1984 - 1990 Corvette: Service Bulletin: Service Part For Seat Cushion Retaining Wire

Number: 90-154-10

Subject: Service Part For Seat Cushion Retaining Wire

Model Year: 1984-1990 Y Car

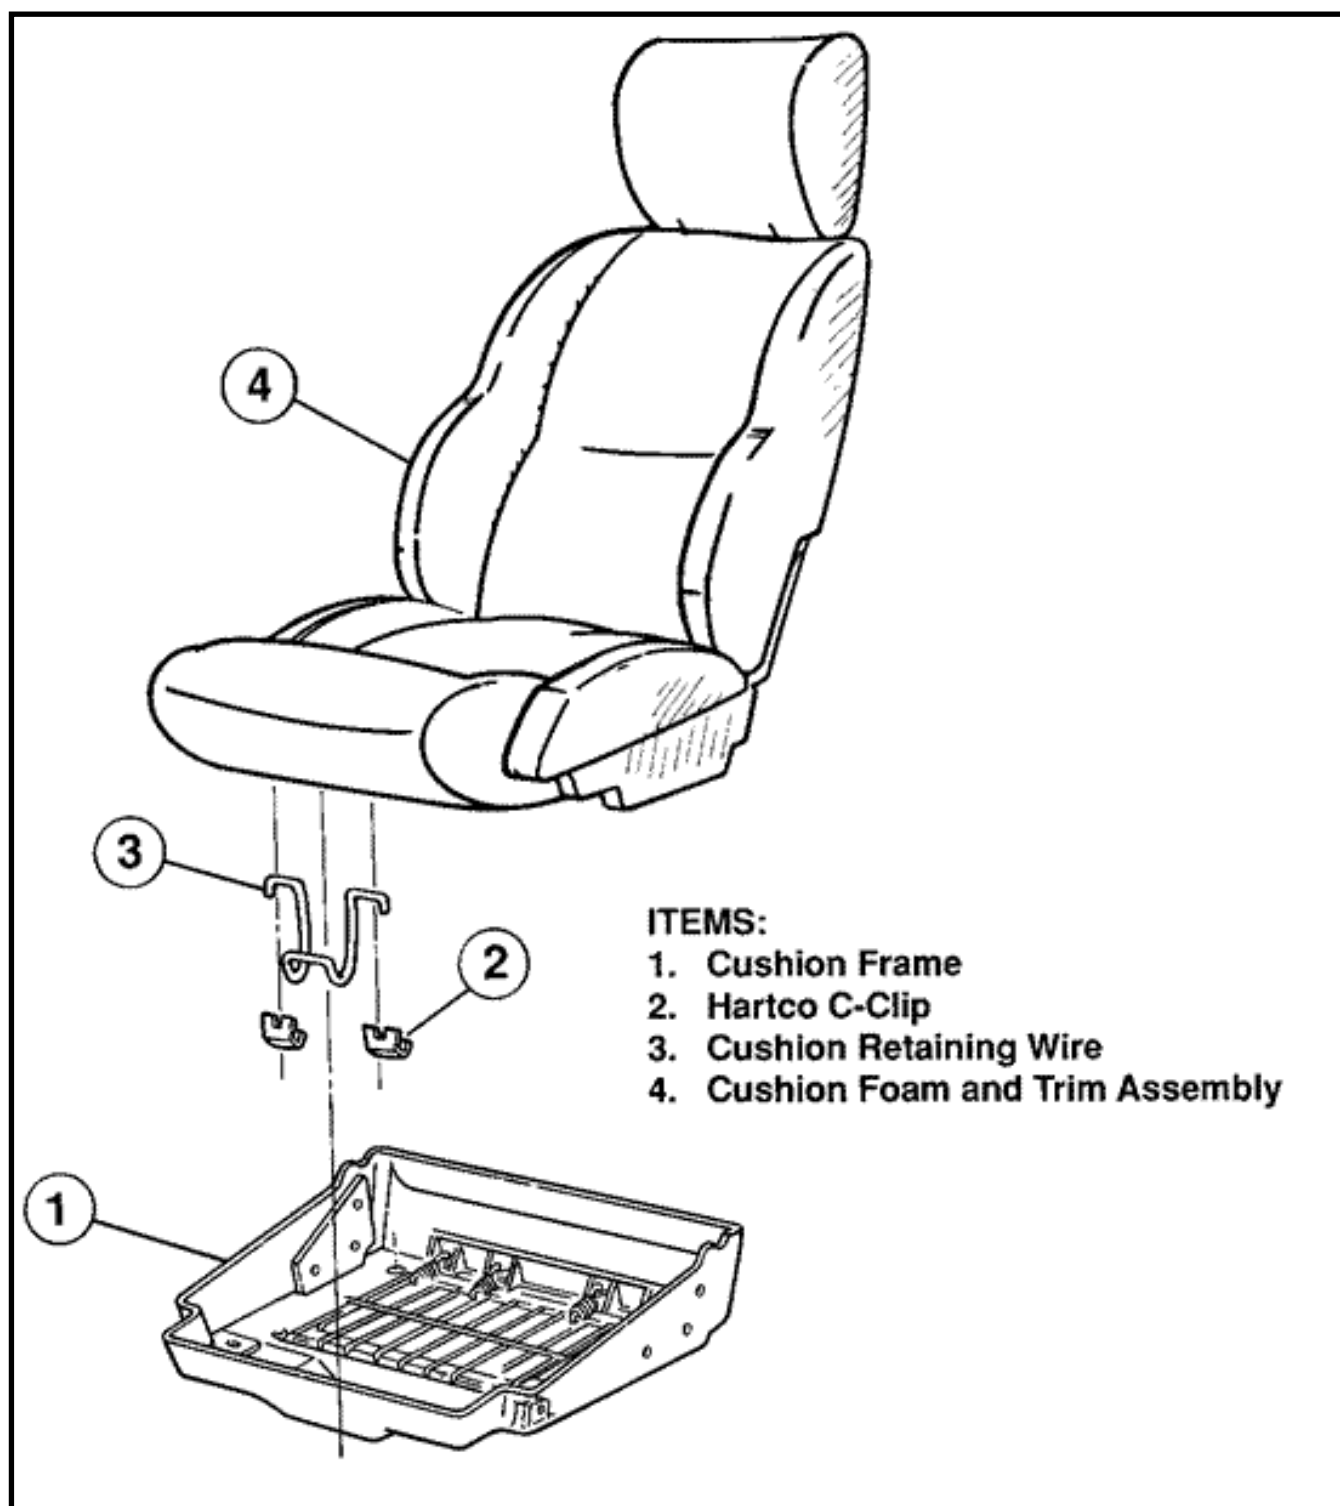
GMSPPO has released for service a cushion retainer wire service kit, P/N 10153686. On current and past model Corvettes, it was necessary to replace the seat cushion if the retaining wire broke. With the release of this kit simply replace the wire retainer as outlined below:

1. Remove cushion from frame by pushing down on top of cushion and unsnapping wire retainer.
2. Using side cufters remove Hartco C-clips from cushion border wire.

1. Position cushion retaining wire legs onto border wire extensions.

IMPORTANT: "J" shape of retaining wire must face toward front of vehicle.

2. Place Hartco clips around cushion retaining and foam cushion border wire. Both sides of clip should be visible. If necessary, pull foam slightly away from border wire.
3. With pliers, crush outer legs of Hartco clip around both cushion wire and legs of retaining wire. Then crush inner leg around wires. Clip should wrap securely around both wires.
4. Reinstall seat cushion to frame by putting cushion retaining wire through hole in frame then pushing down on top of cushion and snapping cushion retaining wire over frame projections.
